Botley West Solar Farm

Name of contributor: Professor David Rogers

I am responding to the Secretary of State's request in his letter dated 11th June 2026 for comments by Interested parties on the Application by PhotoVolt Development Partners (PVDP) on behalf of SolarFive Limited ("the Applicant") for an Order granting Development Consent for the proposed Botley West Solar Farm ("the Botley West Solar Farm").

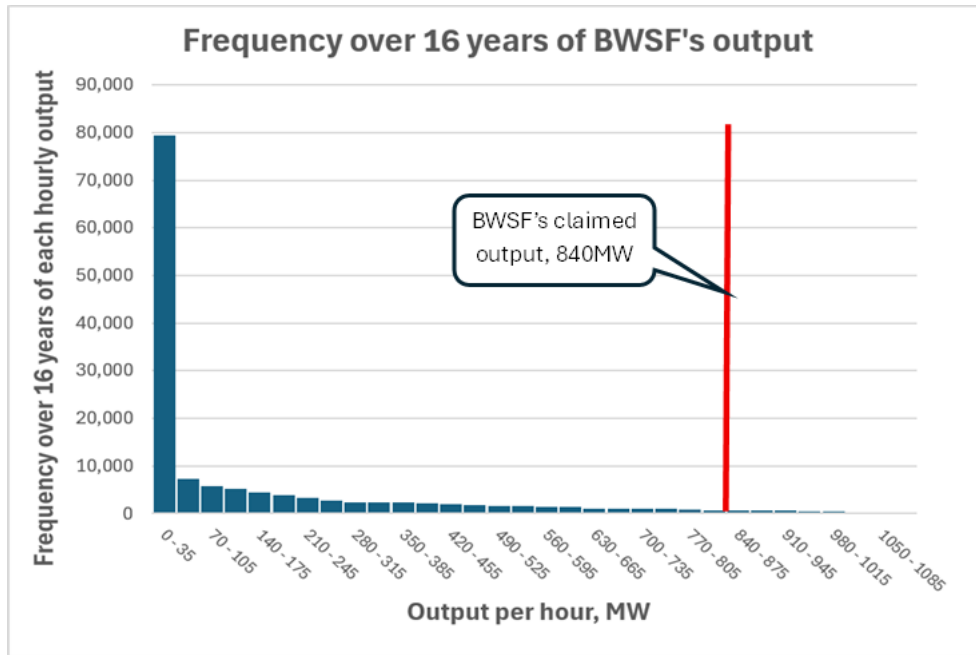
The European PhotoVoltaic GIS system (EUPVGIS) is designed to calculate the predicted output of solar installations across Europe. Putting into the EUPVGIS the various characteristics of BWSF and using a 16-year series (2005 to 2020) of hourly recorded irradiance data (a total of 140,160 observations), gives the predictions shown here in Fig. 1 as a frequency distribution of the output per hour of electricity from a 1307MWp capacity system at BWSF's location in Oxfordshire. Figure 1 shows, on the vertical y-axis, the number of hours (out of that total of 140,610 hours) the output is equal to the values on the horizontal x-axis. Note that the output is less than or equal to 35MWe for almost 80,000 hours (i.e. the tallest column in Figure 1).

It is important to stress that the total annual output from BWSF in kWh per year predicted by the EUPVGIS is within 1% of the applicant's own figure of 1,256,539,474kWh/yr. The IP is in agreement with the applicant about the total annual yield from BWSF. Fig. 1 shows, however, that far from an 840MWe output of electricity being the usual or even a common value from BWSF, the commonest output – occurring for more than half the time (56.6%) - is less than 35MWe. BWSF will reach or exceed an 840MWe output for only 2.2% of the time (to the right of the vertical red line in Fig. 1). 90% of the time BWSF will produce less than 490MWe.

The applicant must stop claiming that BWSF will in any way reliably produce the 840MWe levels of electricity it frequently claims.

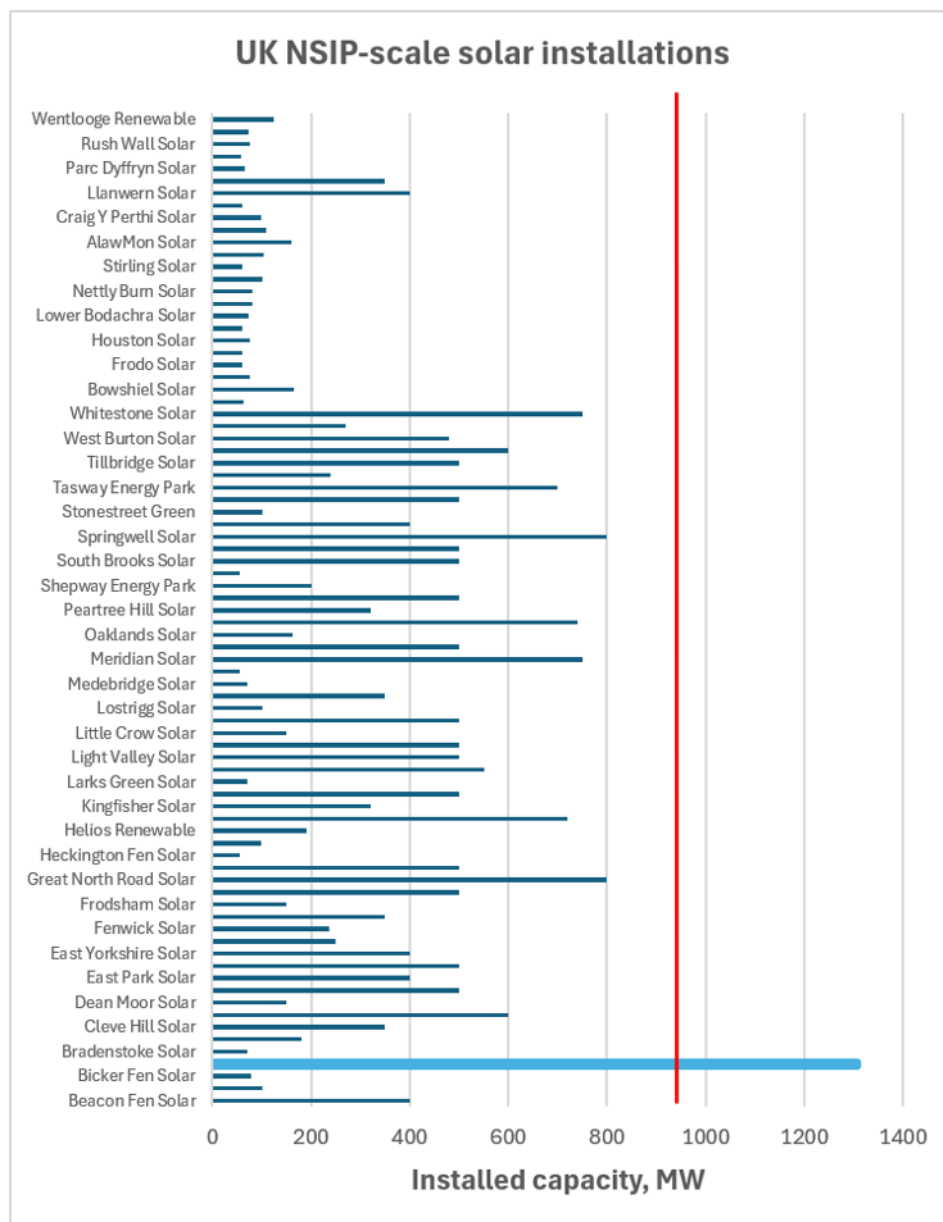
Figure 2 shows Botley West, installed capacity of 1307MWp, as the thick blue line near the bottom of the Figure. The vertical redline shows a capacity of 935MWp, the claimed minimum possible size for BWSF. ALL of the other 80 NSIP-scale solars are below the supposed 'minimum size' for BWSF (i.e. are to the left of the red line in Fig. 2). If they can be economically viable at those much smaller sizes, why cannot BWSF?

The IP is not aware of any special circumstances inflating the costs of BWSF. Thus, the claimed minimum size of 935MWp should be rejected by the SoS. The applicant should be instructed to explore more of the options suggested by the Oxfordshire Host Authorities (OHA) to reduce the size and therefore the social, environmental, landscape and other impacts of BWSF.
